**PRE-APPLICATION CONFERENCE**  
**Lockwood Creek Subdivision (2021-016-PAC) Meeting**  
conducted on Monday, June 7, 2021– 3:00 PM

Site Address	2000 NE Lockwood Creek Road, La Center, WA
Legal Description	#94 SEC 2 T4N R1EWM 20A PIN 209113000
Applicant	Susanna S. Hung, 701 Columbia Street #414, Vancouver, WA 98660
Applicant's Representative	Contact: Nicolle Sicillia or Travis Johnson, PLS Engineering, 604 W Evergreen Blvd., Vancouver, WA 98660 <a href="mailto:Nicolle@plsengineering.com">Nicolle@plsengineering.com</a> <a href="mailto:travis@plsengineering.com">travis@plsengineering.com</a>
Property Owner	Susanna S. Hung, 701 Columbia Street #414, Vancouver, WA 98660
Proposal	Subdivide a 20-acre parcel into 74 single-family lots served by public streets.
Date of Issue	June 14, 2021

**MAP NUMBER**  
**4102-N**

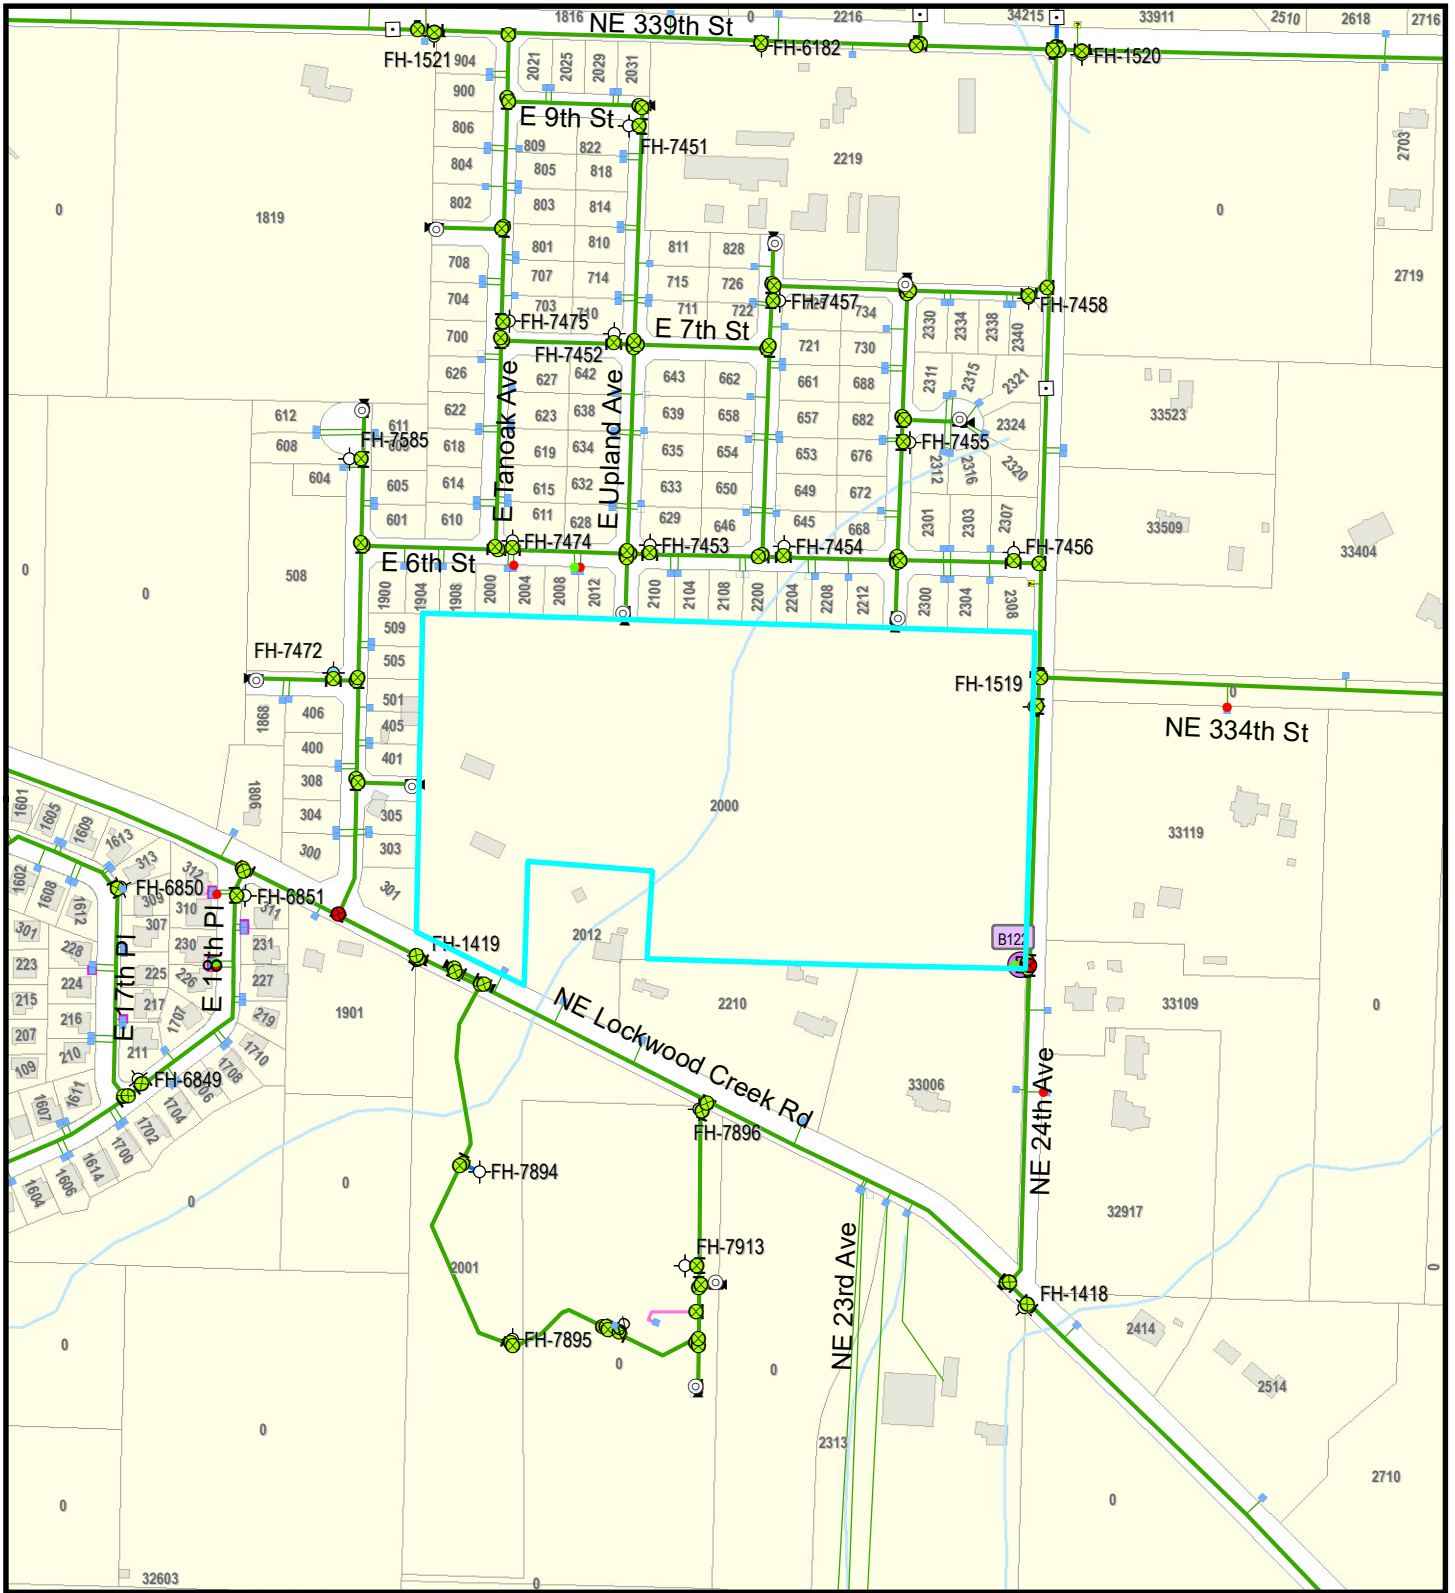
Clark Public Utilities (CPU) is the water purveyor for this site. CPU Water distribution maps indicate that there are existing 8" PVC water main within E 4<sup>th</sup> Way, E Upland Ave, E White Oaks Ave, NE Lockwood Creek Rd, and NE 24<sup>th</sup> Ave and a fire hydrant located along the eastern property frontage. See attached CPU water distribution map for reference. Utility drawings are for reference only and project engineer should verify existing conditions in the field prior to final design.

The fire flow at FH – 7472, located near the intersection of E 5<sup>th</sup> St and E Spruce Ave was previously calculated at 1,954 gpm at 20 psi. Static water pressure is expected to vary, around 135 psi depending on site elevation, system demand and reservoir levels. Due to high anticipated pressure it is recommended that a private plumber be consulted regarding installing privately owned and operated pressure reducing valves. If updated fire flow data is required, please contact Water Services at (360) 992-8022.

For this development, depending on site access and layout, plan to connect to the existing 8" water mains within E 4<sup>th</sup> Way, E Upland Ave, E White Oak Ave, and NE 24<sup>th</sup> Ave. If fire protection is required, extend a minimum 8" water main within the public right-of-way to the site. If fire protection is not required, a minimum 4" water main may be acceptable. Install proper fire protection (i.e. hydrants and building sprinkler systems) as required by the Fire Marshal. Any existing, unused services shall be properly capped and abandoned. All water mains and services (up to the meter) located within private property, shall be included in an easement granted to Clark Public Utilities.
